MEMORANDUM

Re: Water Availability Assessment for Huerfano River and Cucharas Creek Instream Flow Filings

Re: R2Cross Modeling for Cucharas and Huerfano Rivers

**Fig. 1. Geometric Mean Q Cucharas Cr abv LT (prop on Cucharas R at
Boyd Ranch near La Veta, adjusted for irr) & ISFs**

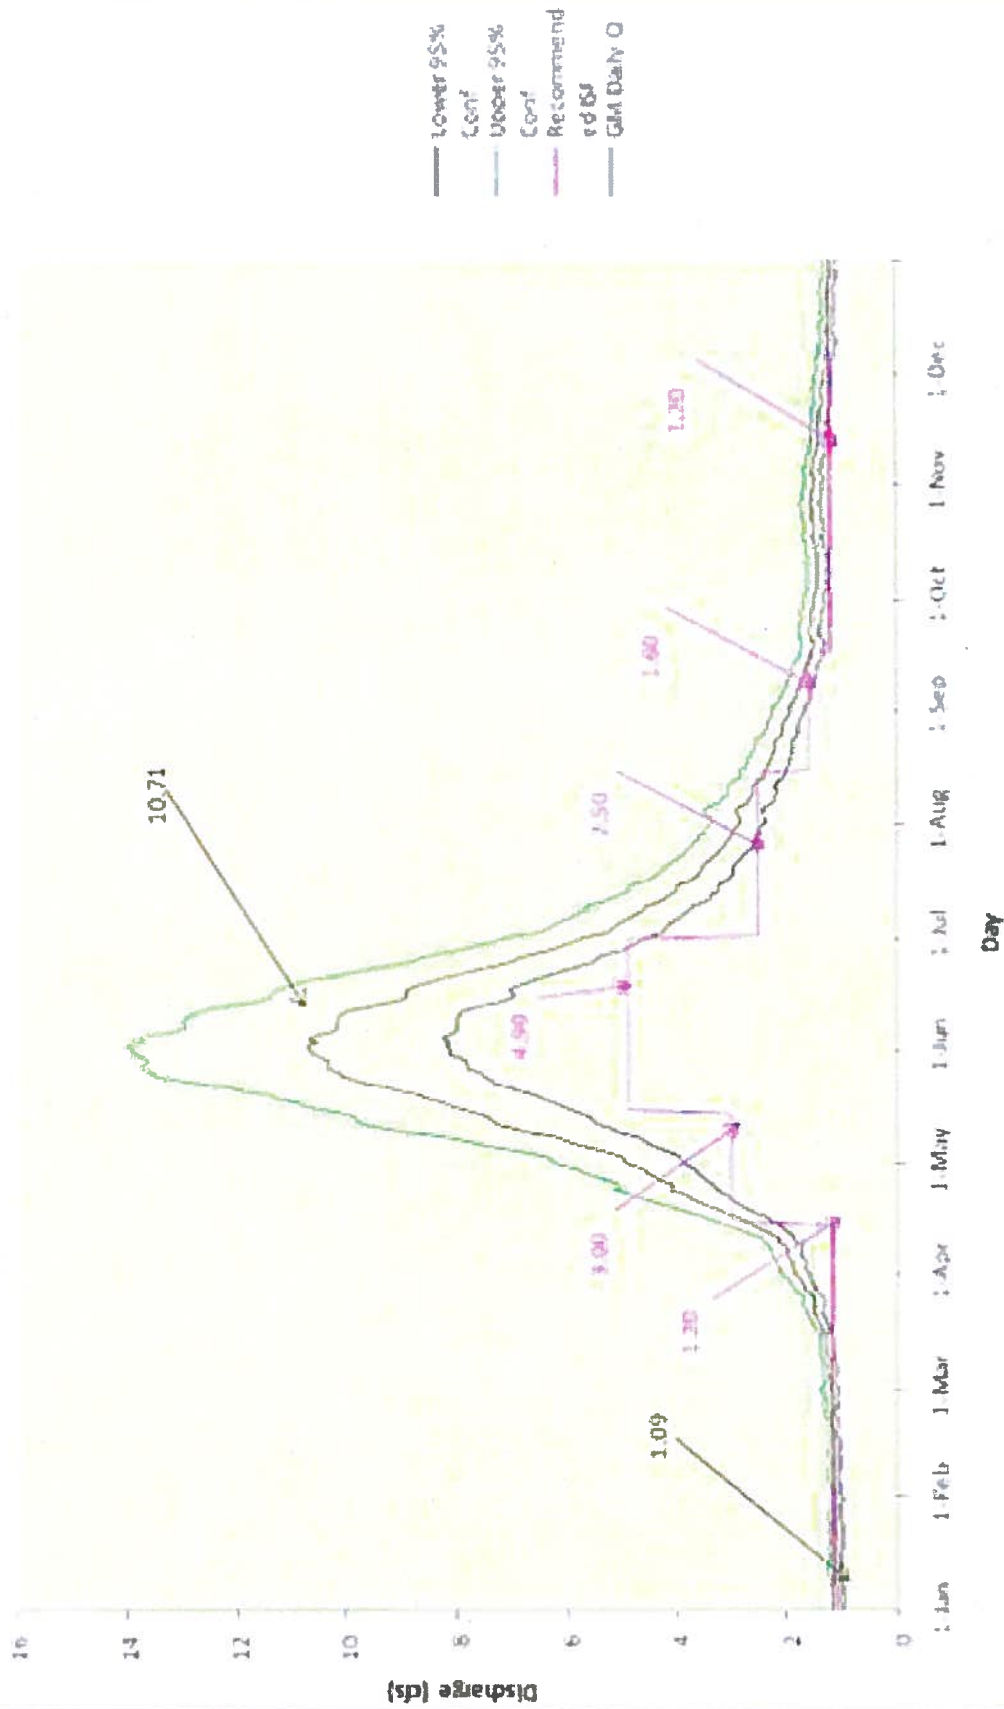
It is not clear whether the pro-rated flows actually had historic diversions subtracted. Graphs were prepared which show the geometric mean daily discharge and ninety-five percent confidence limits with the proposed ISF flow amounts. These graphs (copies in Attachment 1) indicate that the geometric mean daily flow is well above the proposed ISF amounts for the upper Huerfano River segments, and close to the flows for the Cucharas Creek segment.

BWC is concerned with the use of geometric mean daily flows to determine water availability. As described in the USGS's Techniques of Water-Resources Investigations Series by D. R. Helsel and R. M. Hirsch, which is cited as the basis for use of this method in the CWCB documents, the geometric mean is less affected by extreme values or outliers and is a more stable measure of the central tendency of a data set. It is also typically less than the arithmetic mean. However, we question the validity of the use of geometric means to assess water availability for the purpose of setting an ISF. Geometric means may be more appropriate for data that is extremely variable, i.e., data which has a range of several orders of magnitude, or numbers that are multiplied together (e.g., determining the average rate of return on an investment).

Use of the geometric mean reduces the variability in the flow data, but this variability is essential for a realistic assessment of water availability. Water supply planning is typically based on more extreme drought events. The frequency of droughts determines the economic viability of the enterprise for which the water is being used (e.g., irrigation for crop production, municipal water supply, industrial water uses, etc.).
